<b>LEXINGTON-FAYETTE URBAN COUNTY GOVERNMENT</b> <b>CONTRACT CHANGE ORDER</b> Page 1 of 2	Date:	December 7, 2015
	Project:	Masterson Station Park Restroom Building
	Location:	200 Ruffian Way
To (Contractor): Schaefer Contracting, LLC 1068 Macland Rd Lawrenceburg, KY 40342	Contract No.	151-2015
	Original Contract Amt.	\$169,999.00
	Cumulative Amount of Previous Change Orders	\$18,852.00
	Percent Change - Previous Change Orders	11.09%
	Total Contract Amount Prior to this Change Order	\$188,851.00
	Change Order No.	4

PROJECT: Masterson Station Park Restroom Building

CHANGE ORDER: 4

# CHANGE ORDER

**BULLETIN: A3PM**

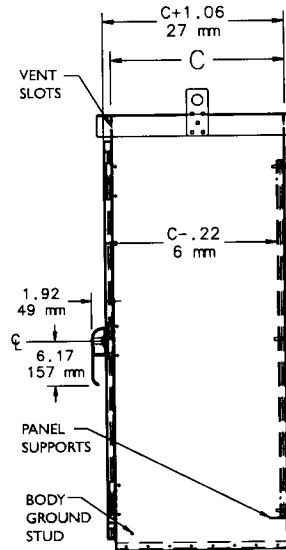
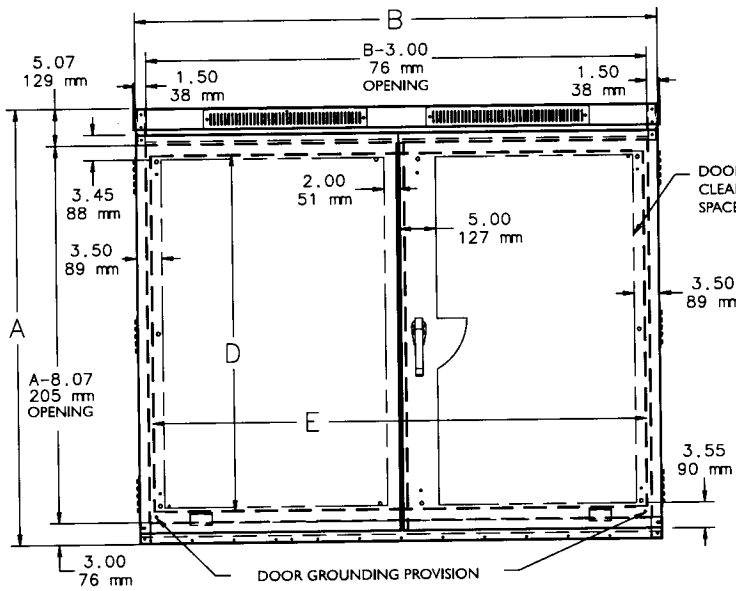
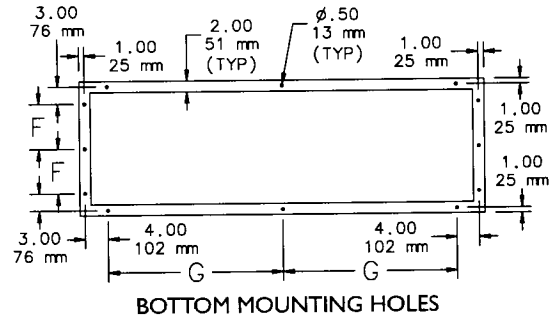
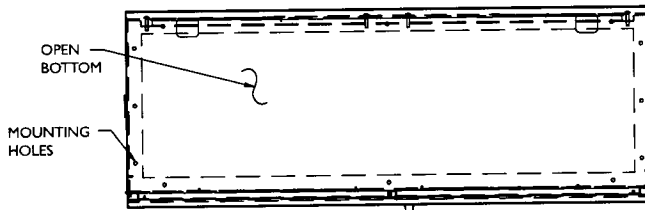
- 60"Wx72"Hx24"D C&I free standing enclosure with lock. The C&I enclosure will contain a 400A NEMA breaker enclosure. A 400A two-pole breaker. A 400A 120/240volt single phase 42 CKT Panelboard (NEMA1.) Panel includes the following breakers: (1) 150A two-pole, (5) 100A two-pole, (6) 60A two-pole. Also, (5) spare 1-1/2" PVC conduits that are to be turned out five feet. Price includes pouring one 8'x8'x6" concrete pad for the enclosure. Transformer, primary cable and conduit by others. Contractor to provide and install conduit and wire on the load side only. All conduit to be PVC, all conductors copper, no rock removal. All materials can be delivered in seven business days, with labor completed three weeks following. \$24,550...Twenty four thousand, five hundred fifty dollars.

(1) 60"x72" x24" C&I free standing enclosure with lock. The C&I enclosure will contain a 400a NEMA breaker enclosure. (1) 400a two pole breaker. (1) 400a 120/240volt single phase 42 CKT Panelboard (NEMA1). Panel includes the following breakers; (1) 150a 2pole,(5)100a 2pole,(6) 60a 2pole. Also, (5) spare 1 1/2" PVC conduits that are to be turned out five feet. Price includes pouring one 8'x8'x6" concrete pad for the enclosure. Transformer , primary cable and conduit by others. Contractor to provide and install conduit and wire on the load side only. All conduit to be PVC,all conductors copper, no rock removal. All materials can be delivered in seven business days. with labor completed three weeks following. \$24,550 .....Twentyfour thousand five hundred fifty dollars.

# CONCRETE PAD DETAIL

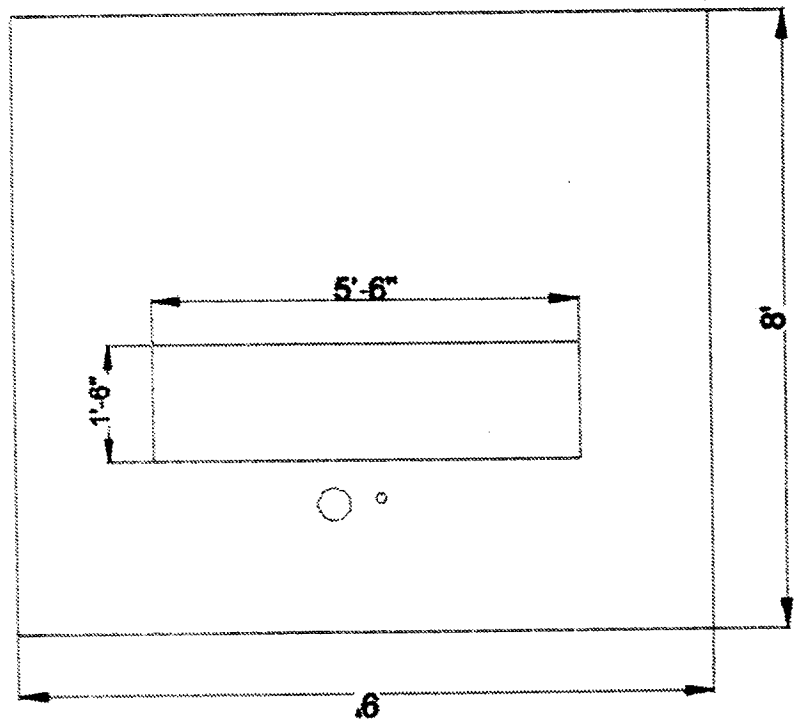
- 52x40 precast concrete pad for a single phase pad mounted transformer.
- 400A self-contained meter base and cabinet. Meter base to be mounted to the back side of the C&I free standing enclosure. Conduit to the meter base shall be GRC where subject to damage.

(1) 52x40 precast concrete pad for a single phase pad mounted transformer.

4 INCHES OF PAD TO BE ABOVE GRADE
